EQUIPMENT UPDATE

Log Number: EU-07-390

Part Description: Safe-T-Temp 5 Cam Timer

Model Affected: As of today all 180UC undercounter dishmachines will be manufactured with Safe-T-Temp Cam Timer.

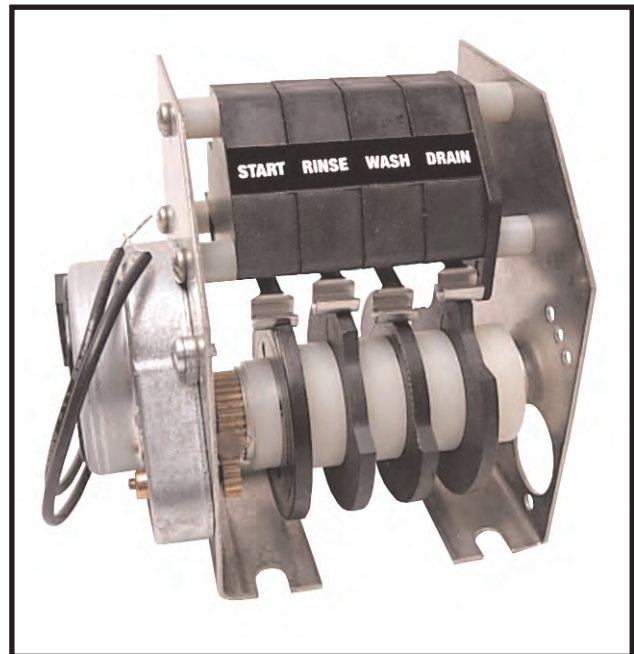
NEW 5 Cam Safe-T-Temp Timer (14510.81)
Timer will pause and machine will remain in wash cycle until booster heater reaches 180°F, then it will advance into a rinse cycle. This will assure the operator of the equipment that the final rinse temperature will be a consistent 180°F every cycle.

Present 4 Cam Timer (14510.80)
Standard 180UC 3 minute timer assembly.
